**COMMENTS OF
WHITE PINE COUNTY, NEVADA
ON THE
DRAFT ENVIRONMENTAL IMPACT STATEMENT
FOR THE
CLARK, LINCOLN, AND WHITE PINE COUNTIES GROUNDWATER
DEVELOPMENT PROJECT**

Submitted: October 11, 2011

Figure 1: Snapshot from Figure 6-9 (SNWA, 2009) showing unweighted residuals.

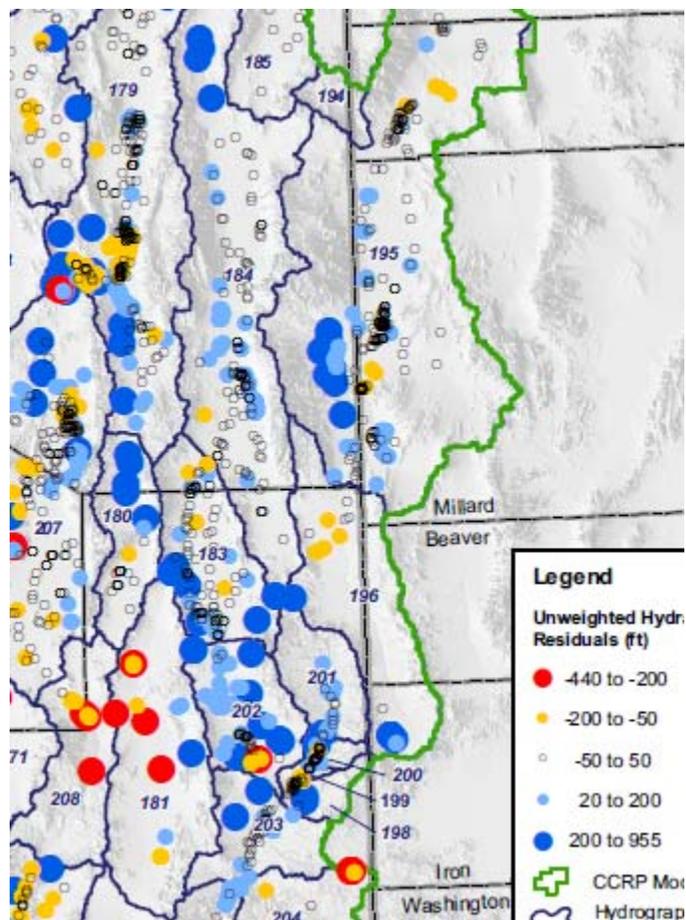
SNWA's model calibration is biased to look better than it actually is. SNWA presented unweighted residuals, in Figure 6-9 (SNWA, 2009), which shows extreme bias in the distribution of residuals. In the area of Dry Lake and Pahroc Valleys, six residuals are between -440 and -220; five more are between -200 and -50 (Figure 1). Just east of Dry Lake Valley, in a trend that looks very much like the PRISM precipitation overestimates in Patterson, Lake, and Cave Valleys, are at least ten residuals from 200 to 955 and another ten from 20 to 200 (Figure 1). The CCRP model ranges from gross overestimation of head in Dry Lake/Pahroc Valleys (simulated exceeds observed in a negative residual) to gross underestimation of heads 10 to 20 miles to the east.

Two other obvious problems are the high positive residuals in north Spring Valley and along the mountain front in Snake Valley (Figure 1). The model does not accurately simulate the water table in the higher elevations along the boundary of the valleys. There should be little confidence in the simulated drawdown in these areas, potentially biasing the predicted results.

Figure 3: Snapshot from Plate 2, Rowley et al (2011).

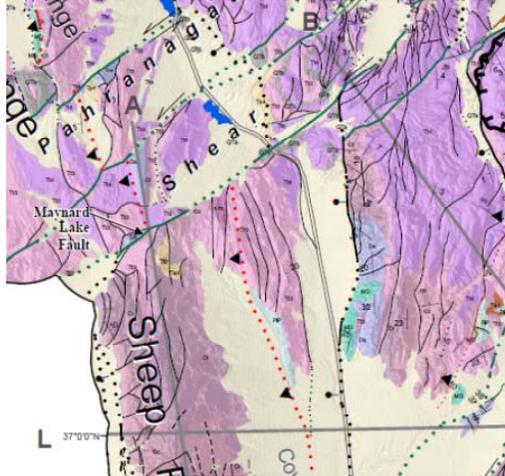
The Pahrnanagat shear zone causes a head drop of about 700 feet across one model cell, as represented by the blue in the hydrogeology at column 62 (Figure 2); this is modeled with a series of HFBs. Further east (right) in column 72 is a conductive fault in LC3 (lower carbonate rock). The conductivity (K) in the fault ranges from 17 to 62 ft/d, over 3281 feet, while the surrounding LC3 cells have K about 0.5 ft/d. The high K fault runs north/south through Coyote Spring Valley to just south of the Pahrnanagat Shear zone (Figure 3); the fault is shown on Figure 3 just east of the highway; it ends approximately where it intersects the shear zone. Based on K, this fault zone would transport vastly more groundwater than the surrounding rock.

Figure 5: Model area near row 407 showing faults. (file xs_rum_rows-rev2-7o-map-hd-kh-s-1lay-ucth814-1-4748.pdf)

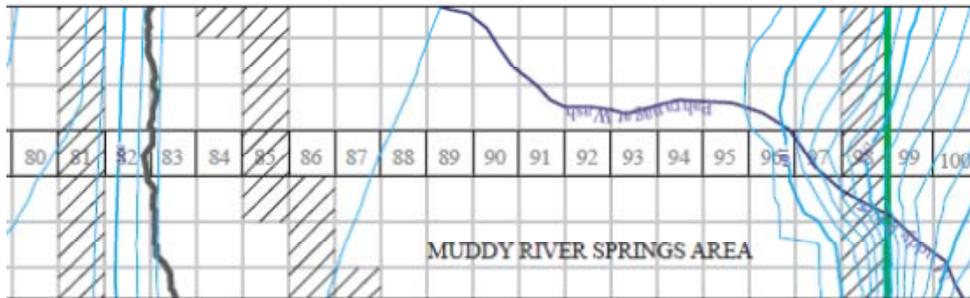
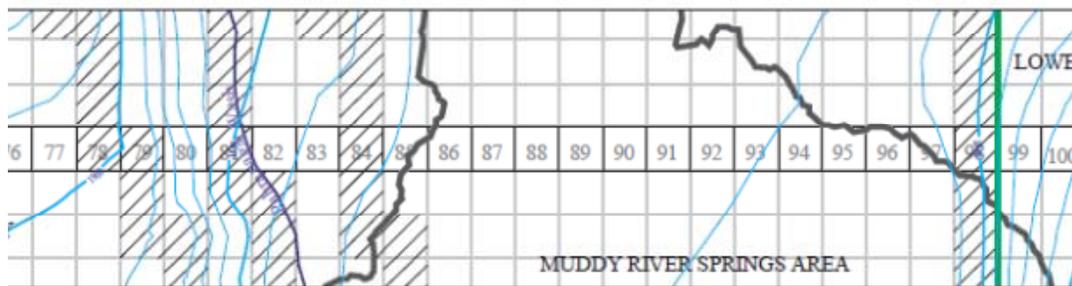
Further south three faults converge in Coyote Spring Valley which allows groundwater to move to the Muddy River Springs area through a zone of very high K LC3 rock. Figure 4 shows two of the faults and high K zones right of the faults; Figure 5 shows the convergence of these faults and the fault on the east which impedes the flow causing it to surface at the springs. Figure 6 shows the three faults north of the springs near their convergence into the broad high K LC3 material. These figures demonstrate how a model simplifies complex geology but the problem with this is the broad zones with very high K cover as much as 20 model rows by 15 columns, or about 300 square kilometers. There is no geologic evidence for such a broad fractured zone in this area. Such a zone may bias the results for this area. The springs probably discharge from a narrow highly conductive fracture zone which could be drained sooner by pumping than would a 300 square km, 10,000 feet thick zone, with high K.

SNWA should use different storage coefficients for the high K zones. Clearly, highly fractured areas would have different storage properties than unfractured media.

Figure 7: Snapshot of portion of row 128 in center of Spring Valley showing hydrogeology (upper) and K (lower). (file xs_rum_rows-rev2-7o-map-hd-kh-s-1lay-ucth814-1-4748.pdf)

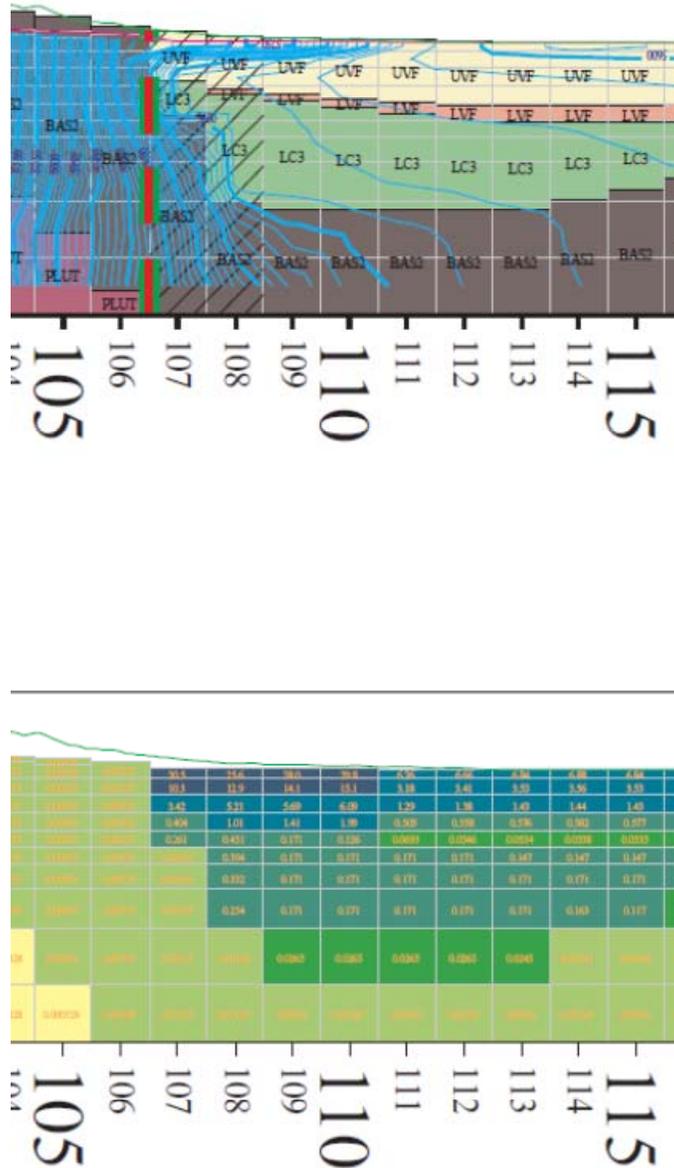
The CCRP model simulates Spring Valley with faults on each side, but only the normal fault on the west side affects the flow (Figure 7). An HFB runs between the bedrock and fill, causing a significant head drop. The bedrock is all low K, therefore the flow into the fill is probably low; the northern portion of Spring Valley has mostly mountainfront recharge. The east side fault shows as large displacement, but the K is not significantly different from the surrounding rock.

SNWA uses high K cells on the boundary in the uppermost layers. These presumably were set to allow recharge into the zone near the mountain front. Underlying the high K cells, the K is an order of magnitude lower, which causes the groundwater to pond.

Figure 8: Snapshot of row 160 showing hydrogeology from Steptoe Valley (left) to Spring Valley. (file xs_rum_rows-rev2-7o-map-hd-kh-s-1lay-ucth814-1-4748.pdf)

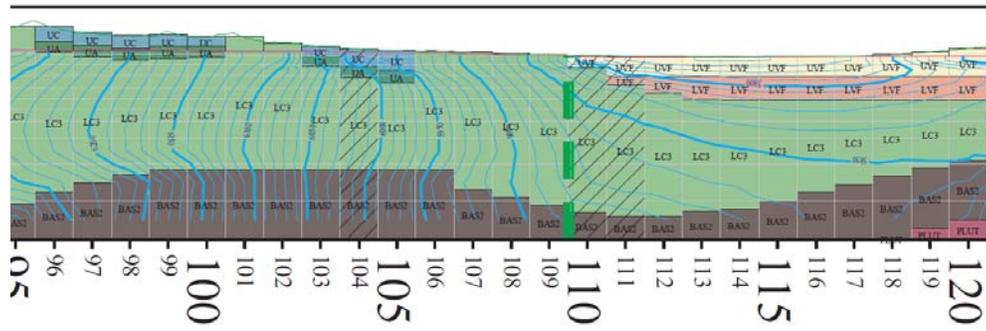
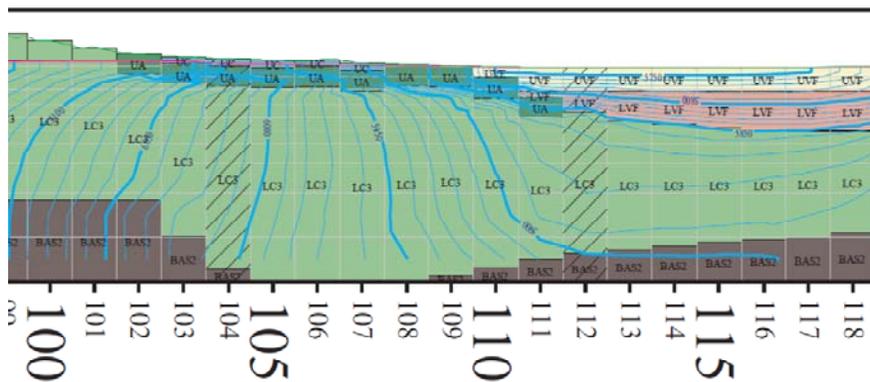
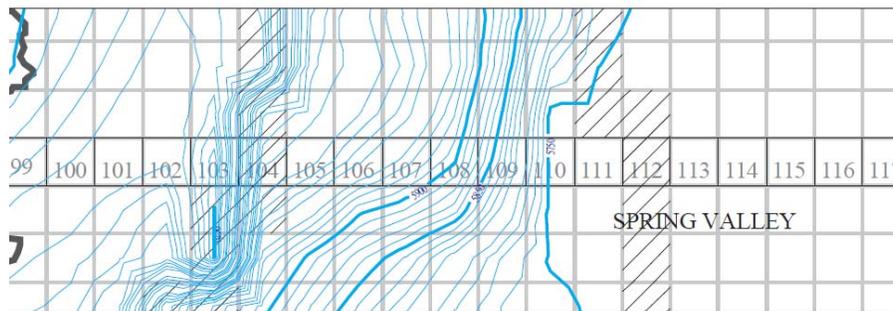
Groundwater contours along row 160 show a gradient through carbonate rock from Steptoe to Spring Valley (Figure 8). The model includes an HFB, but no mounding of contours. This is an example of how the CCRP model allows flow from Steptoe to Spring Valley, in contradiction to their geology models. Figure 9 and 10 demonstrate how a groundwater level contour map can show a divide while there is clearly flow at depth.

Figure 11: Snapshot for Row 100 showing groundwater contours and hydrogeologic formations near Gandy Warm Springs, near column 148.

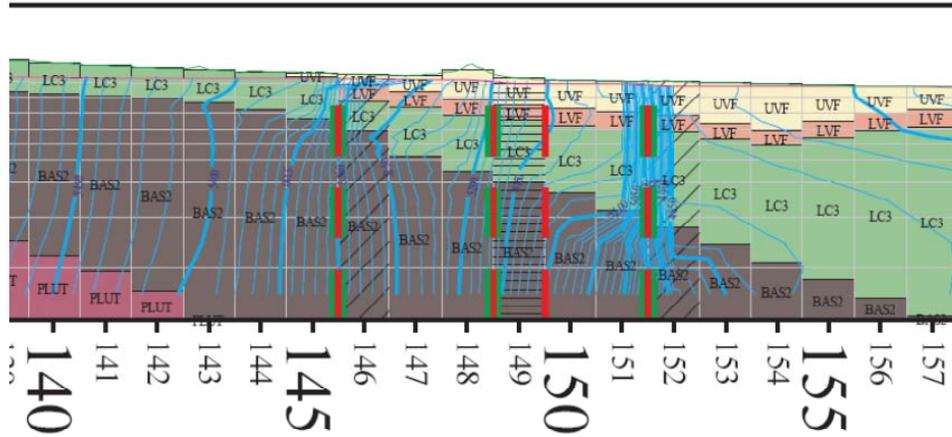
SNWA misses the two most likely sources of water to the spring: the substantial carbonate rock on the northeast side of the Snake Range southwest of the spring and interbasin flow from Spring Valley. A fault diverts flow from the Snake range. SNWA discounts the idea that interbasin flow from Spring Valley could support the spring (NMR, page 5-6). This is curious because the model simulates 11,800 af/y of interbasin flow to just north of Snake Valley which is

C72 cont'd of the same order of magnitude as the approximately 16,000 af/y estimated for this region in BARCASS (Welch et al, 2008, Figure 41). If even a third of that amount combined with carbonate recharge in the northeast portion of the Snake Range, the Gandy Warm Springs flow could be accurately reproduced.

Figure 12: Snapshot of row 202 showing hydrogeology (top) and K values near Shingle Pass. (file xs_rum_rows-rev2-7o-map-hd-kh-s-1lay-ucth814-1-4748.pdf)

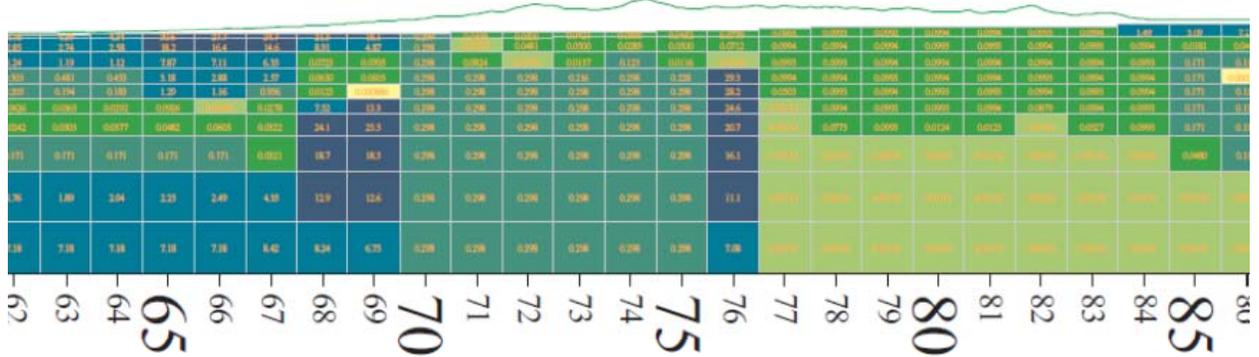
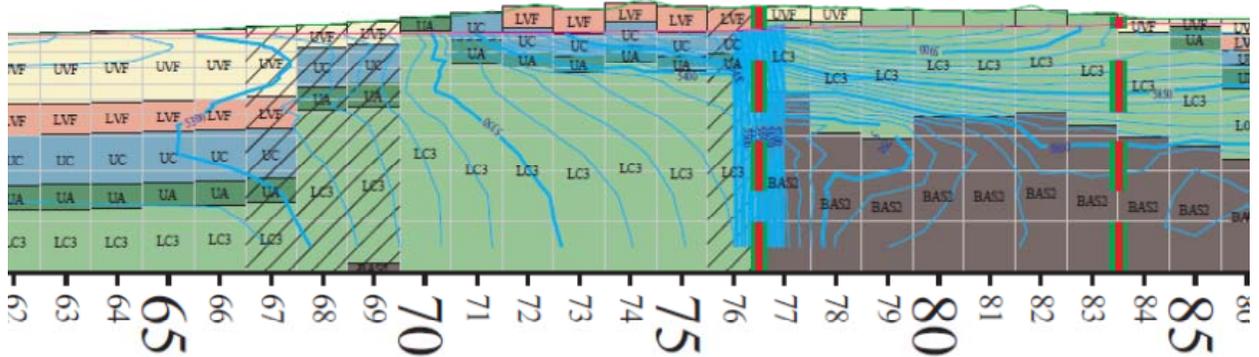
The model conceptualization of Shingle Pass is as complicated as any in the model, with several formations including carbonate rock and several faults (Figure 12). The faults within Cave Valley are simulated with HFBs which prevent flow from leaving Cave Valley. The mountain front faults on the east side of White River Valley have very high K, being high displacement faults. The high K zones extending north and south along the west side of the

Egan Range capture and transmit substantial recharge from the mountains to the springs. However, SNWA does not include an HFB on these faults which would force water to surface in to the springs. Thus, the model is biased so that Cave Valley flow does not support the springs in two ways – HFBs within Cave Valley prevent flow from reaching White River Valley and high K faults along the east side of WRV bring water from the north to the springs rather than from the east.

Figure 13: Portion of model row 126 near the east side of the Snake Range near Baker. White lines are cells, blue lines are groundwater head contours. Other colors represent hydrogeologic units as labeled.

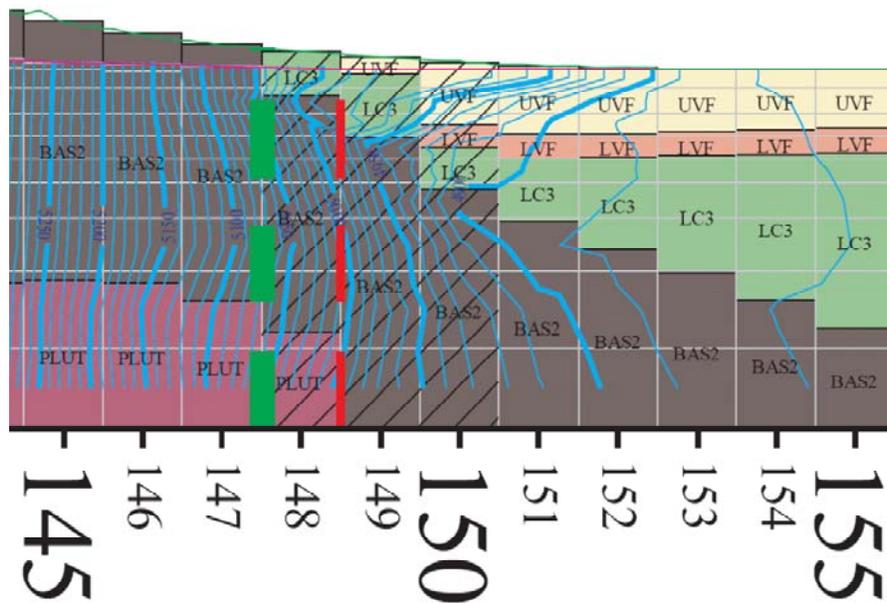
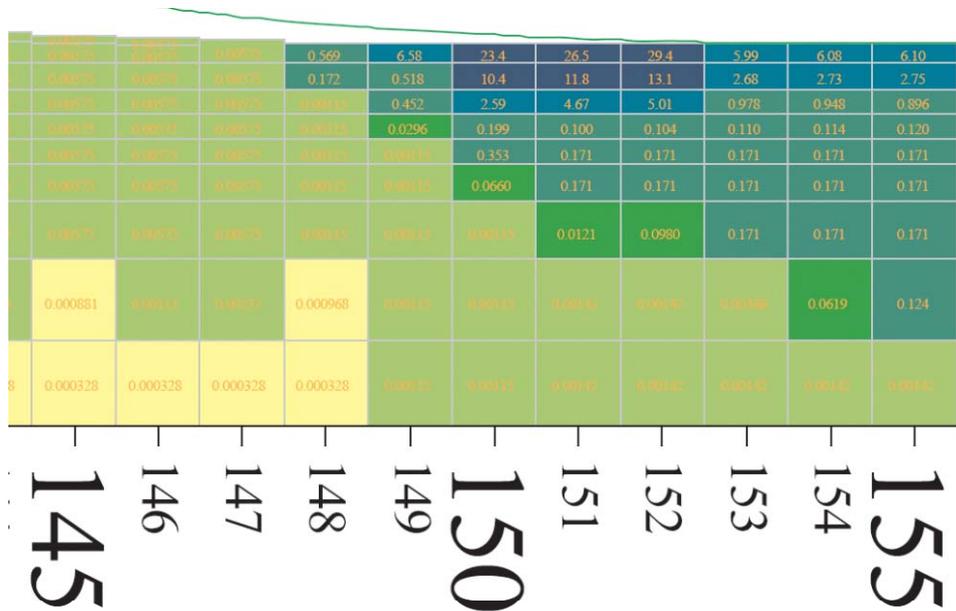
The east front of the Snake Range, near Baker, is a great example of inappropriately averaging formations in one cell. As may be seen (Figure 13), on column 149, the model averages UVF and LC3 properties. In column 150, the model averages LVF and LC3 properties. Considering the conductivity values by cell, the model combined values that differ by more than an order of magnitude (Figure 14). Also, the model would not allow continuous flow among columns within the LC3 unit under Snake Valley because the unit does not match in adjacent cells (Figure 13). This forces the groundwater to follow unrealistic pathways. It would essentially force water in the LC3 unit in column 149 to flow into the LVF unit in column 150.
